Safety Evaluation Report

Transition to AREVA NP Fuel  
and Safety Analysis Methodology

Calvert Cliffs Nuclear Power Plant

SAFETY EVALUATION BY THE OFFICE OF NUCLEAR REACTOR REGULATION  
RELATED TO AMENDMENT NO. 297 TO RENEWED  
FACILITY OPERATING LICENSE NO. DPR-53  
AND AMENDMENT NO. 273 TO RENEWED FACILITY OPERATING LICENSE NO. DPR-69  
CALVERT CLIFFS NUCLEAR POWER PLANT, LLC  
CALVERT CLIFFS NUCLEAR POWER PLANT, UNIT NOS. 1 AND 2  
DOCKET NOS. 50-317 AND 50-318

FIGURE 1: Calvert Cliffs Unit 2 Cycle 19 Rod Power Histories

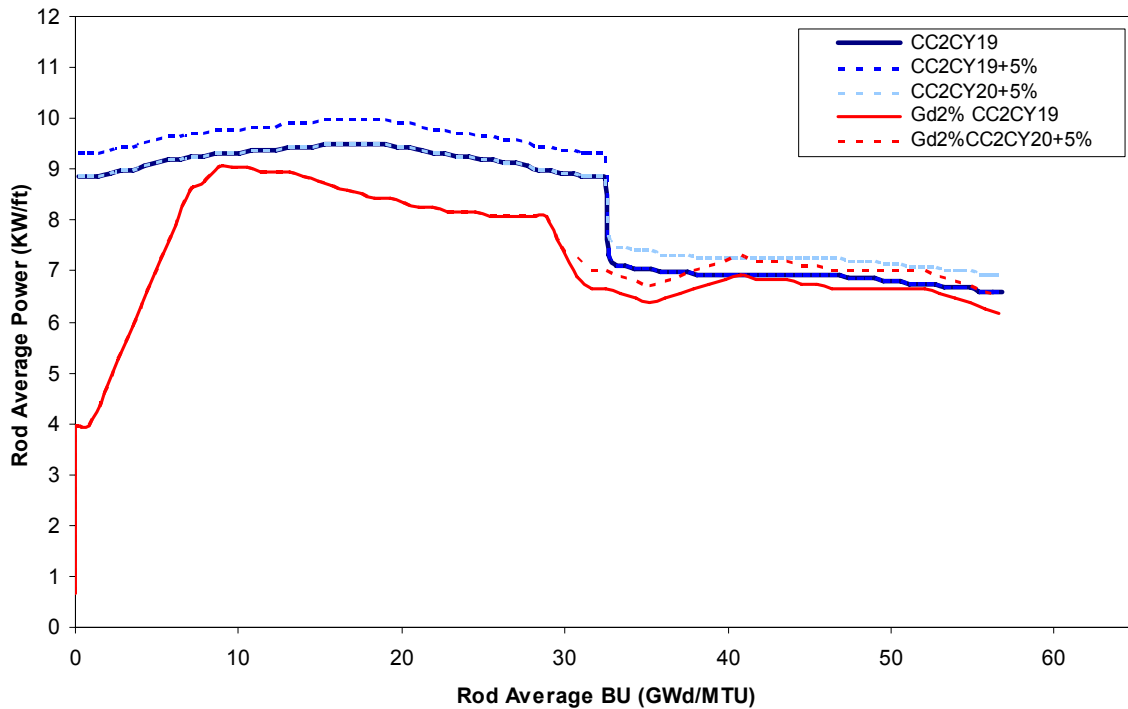
Table 1 provides the results of the NRC staff's independent calculations of rod internal pressure along with the limiting values from the AREVA design analysis. For the limiting UO<sub>2</sub> fuel rod power history shown in Figure 1 (with the addition of power adjustments and AOO power ramps in accordance with XN-NF-82-06(P)(A), "Qualification of Exxon Nuclear Fuel for Extended Burnup"), RODEX2 calculated a maximum rod internal pressure of [ ] psia. Neglecting the power adjustments and power ramps and following the cycle-specific rod depletion power history depicted in Figure 1, a best-estimate, nominal FRAPCON-3.4 calculation yielded a peak rod internal pressure of [ ] psia. With the application of manufacturing tolerances and fission gas release model uncertainty, FRAPCON-3.4 predicted a 95/95 UTL rod internal pressure of [ ] psia. At [ ] psia, the difference in predicted rod internal pressure contributed to the staff's concerns.

If the RODEX2-to-FRAPCON-3 benchmark (documented in response to RAI #28 of Reference 9) had used identical rod power histories, the difference between the two code predictions decreases (and potentially reverses) and the basis for concluding that RODEX2 rod internal pressure predictions are adequate and conservative becomes questionable. For example, with the application of a 5% uncertainty on the Cycle 20 core reload depletion rod power history (consistent with XN-NF-82-06(P)(A) for less limiting cycles), FRAPCON-3.4 predicted a 95/95 UTL rod internal pressure of [ ] psia. The application of the remaining two adjustments [ ] would certainly increase the FRAPCON-3.4 predicted rod internal pressure and exacerbate the difference between the two codes.

The results of the NRC staff's FRAPCON-3.4 calculations and the licensee's response to RAI#28 did not resolve concerns regarding the application of the legacy RODEX2 fuel performance code to CCNPP. However, the results of the FRAPCON-3.4 calculations do provide a degree of assurance that the CE14HTP fuel rod design will not fail as a result of rod internal pressure. Examination of Table 1 reveals that the rod internal pressure criteria are satisfied. Specifically, the maximum calculated rod internal pressure (UO<sub>2</sub>+ToI+FGR+CY20Pow, [ ] psia) is less than the limit of [ ] psia and the gadolinia fuel rods are less limiting than the UO<sub>2</sub> fuel rods. This conclusion is based on the relatively benign rod power histories shown in Figure 1. As described in Appendix F of 32-9135500-001, the licensee intends to employ more aggressive fuel utilization in future cycles with a full core of AREVA CE14HTP fuel. As such, the staff's calculations and conclusions may not be applicable to future cycles.

In response to an RAI regarding the difference in predicted rod internal pressure, the licensee provided RODEX2-to-FRAPCON-3 comparisons for three different rod power histories<sup>9</sup>. AREVA executed the publically available FRAPCON-3 code as part of this benchmark. For each RODEX2 case, the rod power history was adjusted and power ramps were added in accordance with XN-NF-82-06(P)(A). None of these power adjustments were included for the FRAPCON-3 calculations. Figure 28-1 of Reference 9 illustrates the various rod power histories. Based upon this benchmark, the license concludes that the RODEX2 methodology
